Application reference: A006908849

Address of site: 68 Browning Street, South Brisbane QLD 4101

SUPPLEMENTARY MATERIAL TO PROPERLY MADE SUBMISSIONS: MATTERS ARISING FROM THE APPLICANT'S POST NOTIFICATION MATERIAL

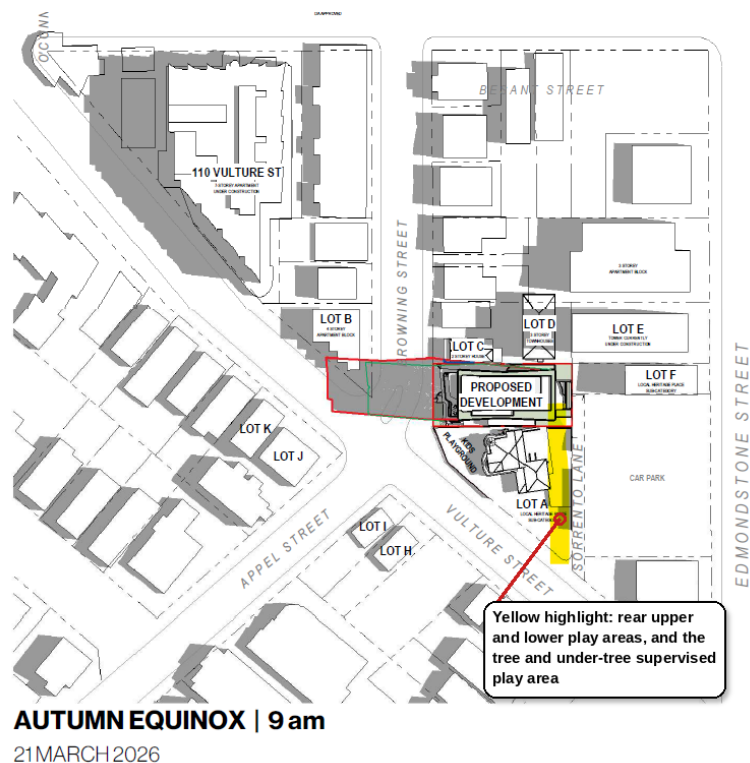
2. In any event, the absence of an overshadowing control directed at non residential receivers in one performance outcome of one code is not an authorisation to overshadow. PO1 of the neighbourhood plan code, set out in Council's own further advice, requires development that improves the amenity of the neighbourhood plan area, and is not confined to residential receivers, and the overall outcomes of both codes remain engaged.
3. The applicant's own revised shadow study quantifies the impact it describes as limited. The winter solstice sheet within the revised Attachment B plans records, for Lot A, which the applicant's own diagram annotates as the heritage sub category lot including the kids' playground, a first shadow impact at 9am, a last impact at 3pm, and a duration of 6 hours, while every other neighbouring lot in the same table records a duration of zero or under one hour.

On the shortest day of the year, on the applicant's own figures, the childcare outdoor areas lose effectively the whole usable outdoor day, and the overshadowing burden of the development falls almost exclusively on the one adjoining lot occupied by young children.

The characterisation of these shadows in the written responses as fast moving and of limited impact cannot stand with the applicant's own table. Nor is the pattern seasonal: the

corresponding tables record durations on Lot A of 5 hours at the spring equinox, 4 hours at the autumn equinox and 3 hours at the summer solstice, in every case ending at 3pm, and in every season Lot A records the longest duration of any neighbouring lot. On the applicant's own tables, there is no day of the year on which the development does not shadow the childcare land through the afternoon.⁶
